CITY OF ALBANY
Alameda County, California

CONSTRUCTION OF
BRIGHTON AVENUE GREEN STREET PROJECT
CONTRACT NO. C16-12

ADDENDUM NO. 1

DM-1

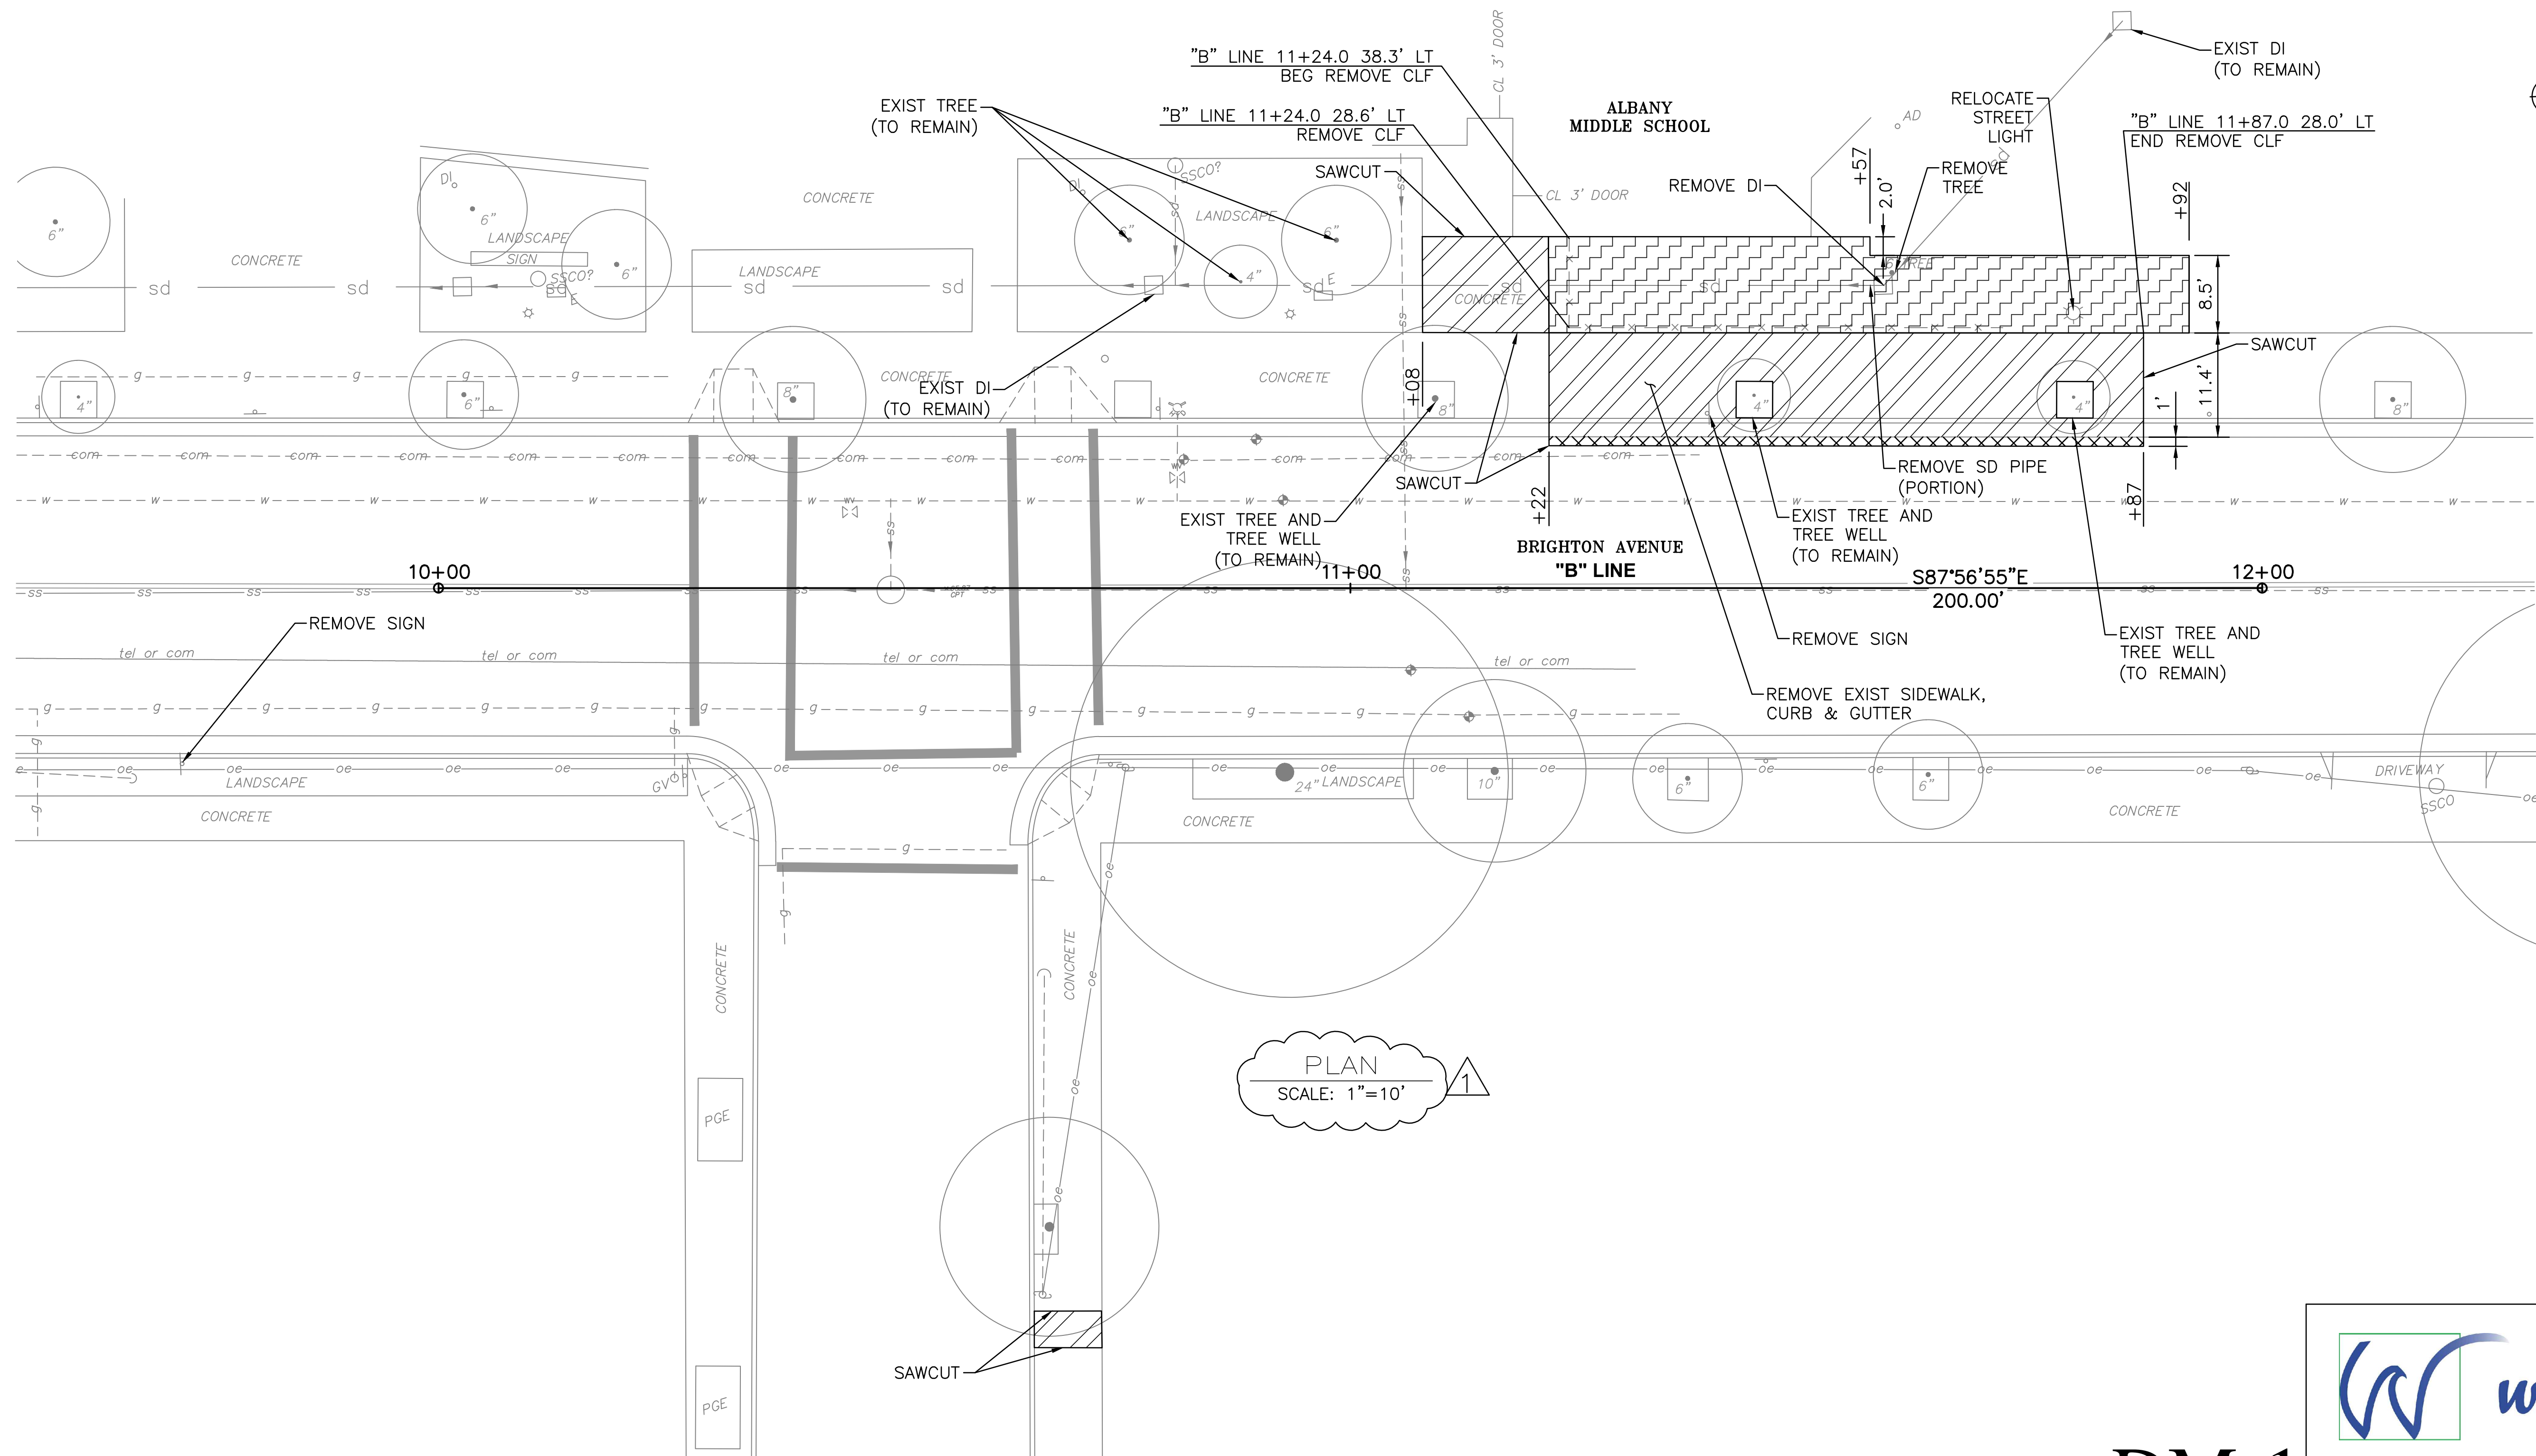
1. **SHEET DM-1**

Incorrect callout to sheet scale

The sheet scale callout has changed from 1" = 20' to 1" = 10' as the callout was labeled incorrectly.

L-1

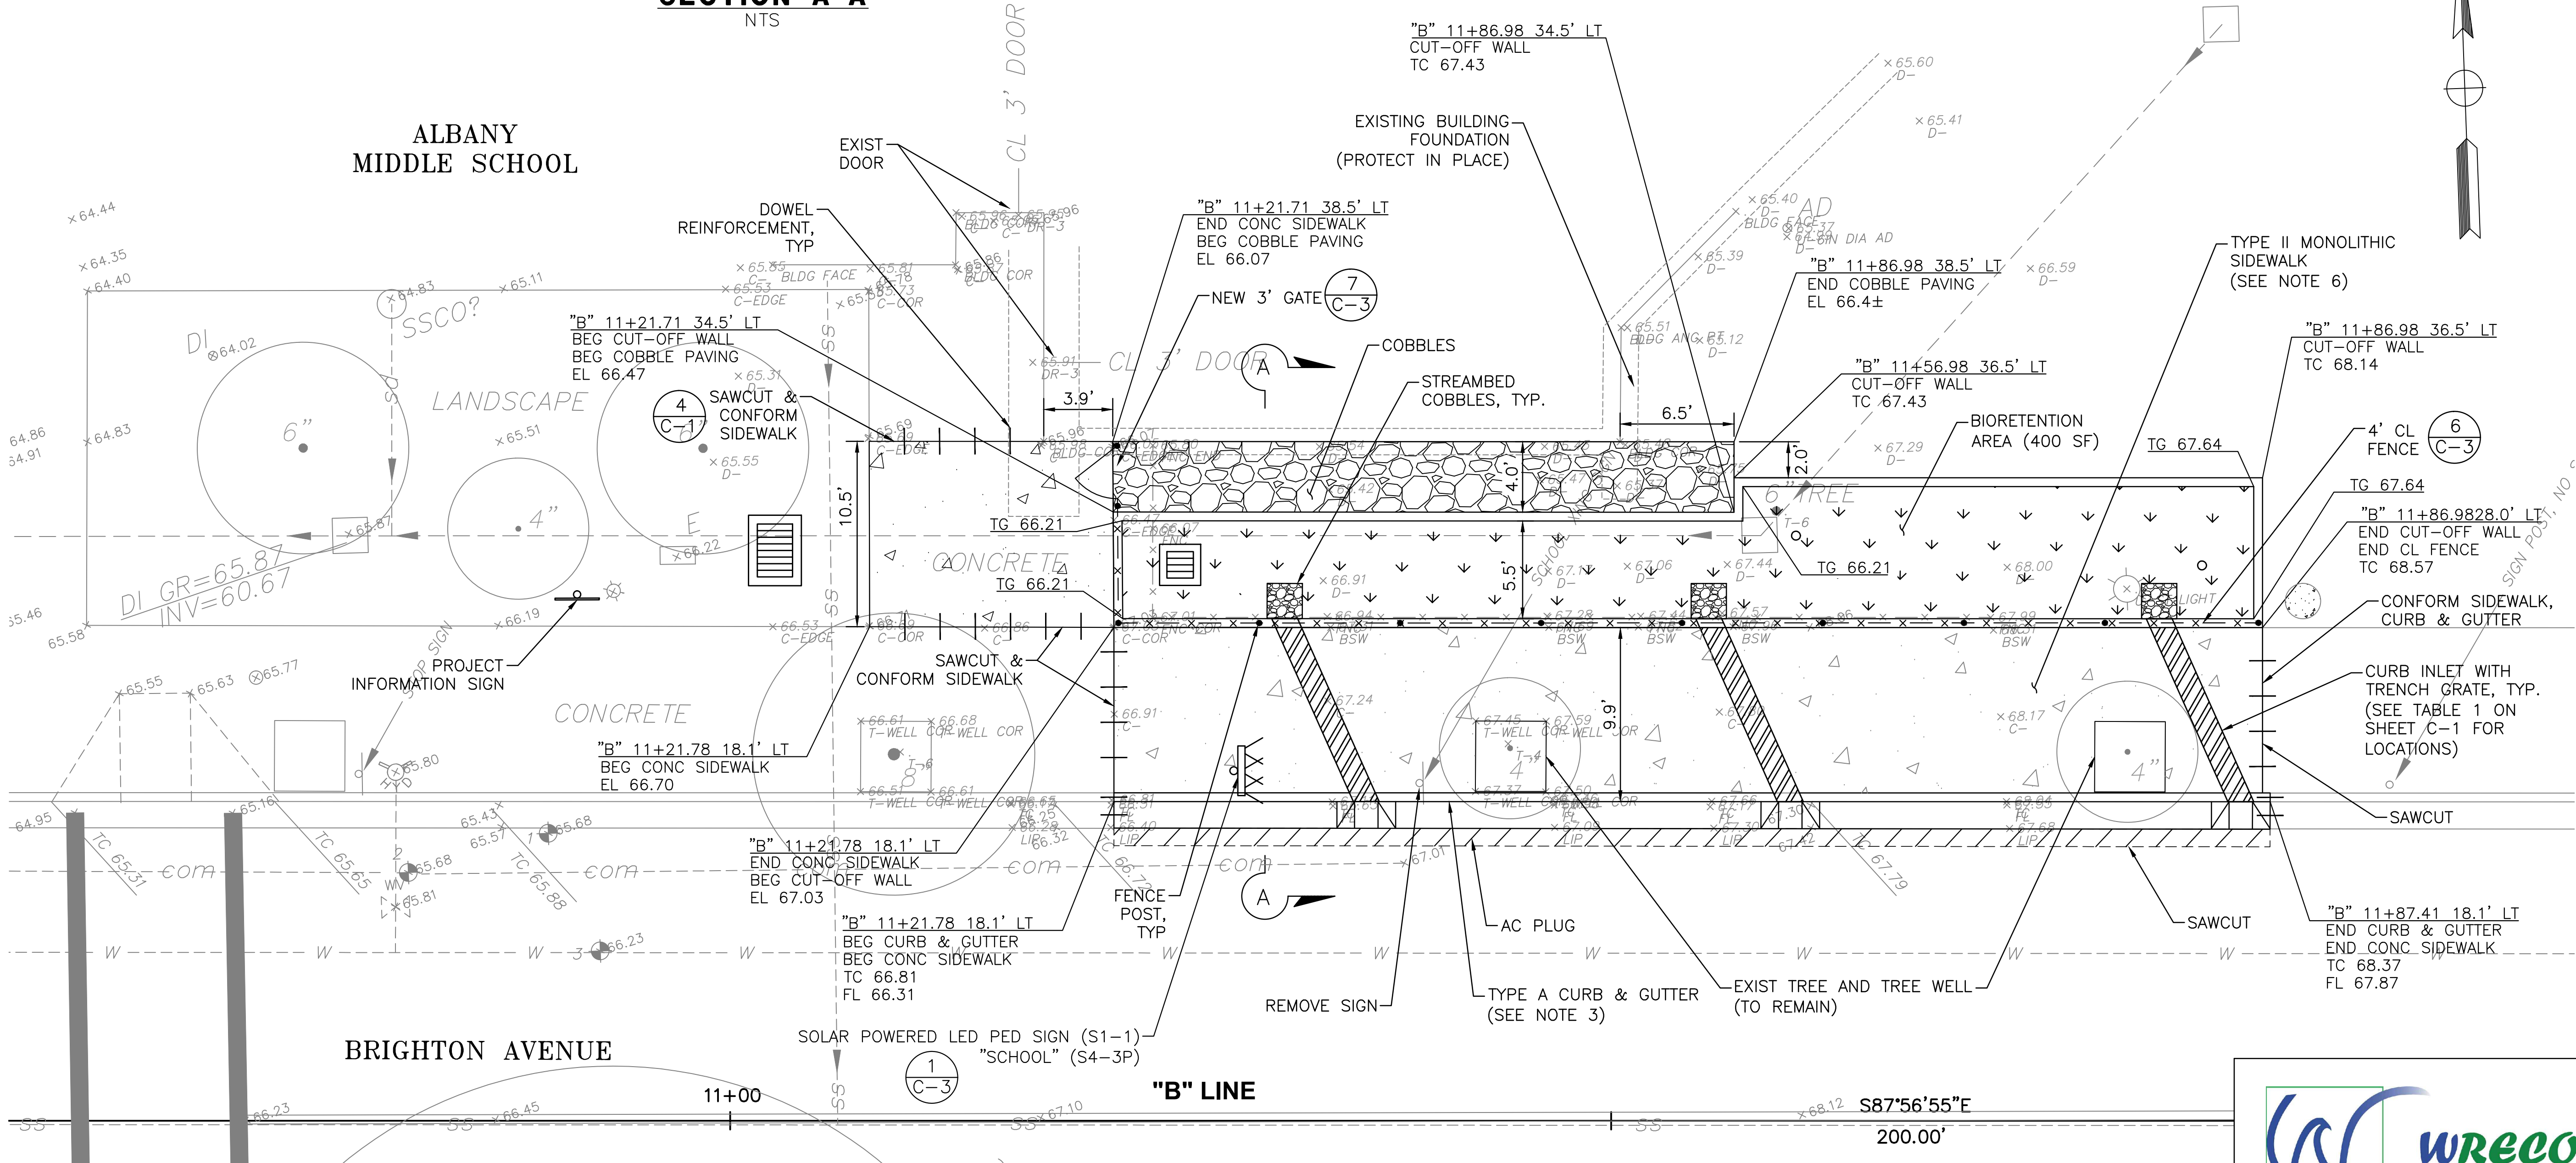
2. **SHEET L-1, L-2 & D-1**

Incorrect callout to sheet scale

The sheet scale callout has changed from 1" = 10' to 1" = 5' as the callout was labeled incorrectly.
